DEVELOPMENT APPLICATION ASSESSMENT REPORT

Application Number:	DA2023/1783
----------------------------	-------------

Responsible Officer:	Lachlan Rose
Land to be developed (Address):	Lot 1A DP 382200, 49 Forest Way FRENCHS FOREST NSW 2086
Proposed Development:	Construction of a secondary dwelling
Zoning:	Warringah LEP2011 - Land zoned R2 Low Density Residential
Development Permissible:	Yes
Existing Use Rights:	No
Consent Authority:	Northern Beaches Council
Land and Environment Court Action:	No
Owner:	Abroyal Singh Amrit Sandhu
Applicant:	Alaa Kharroubi

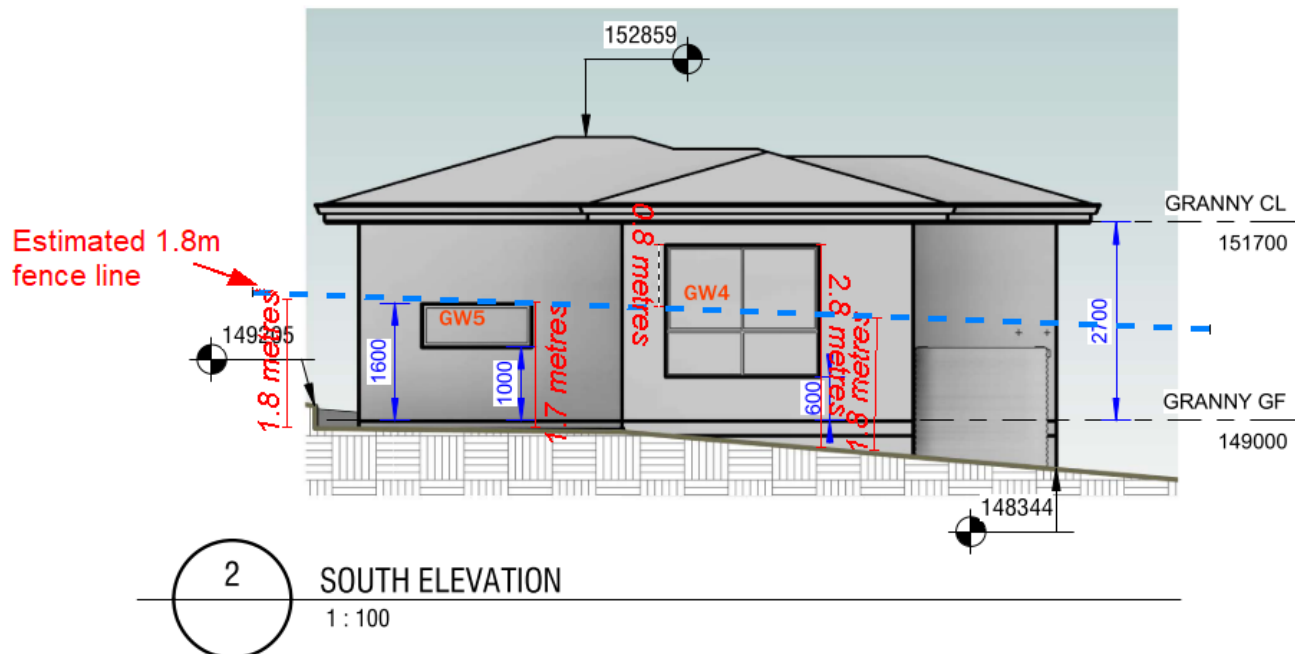
The shadow diagrams reflect minor overshadowing impacts for adjoining neighbours to the east (No. 25 Adams Street) and south (No.47 Forest Way) . Submissions have been received by these adjoining neighbours following the notification, however an assessment of the proposal is conducted below in consideration of objectives of the control.

The sloping topography of the site and orientation of the lots impact overshadowing. Notwithstanding, there are opportunities for sites to the east and south to obtain solar access within the front and rear of the sites.

The proposal includes a single story secondary dwelling that is well under the height limit and meets the side setback controls.

Reasonable access to sunlight will be maintained, satisfying the requirements of control D6 Access to Sunlight requiring *'At least 50% of the required area of private open space of each dwelling and at least 50% of the required area of private open space of adjoining dwellings are to receive a minimum of 3 hours of sunlight between 9am and 3pm on June 21'*.
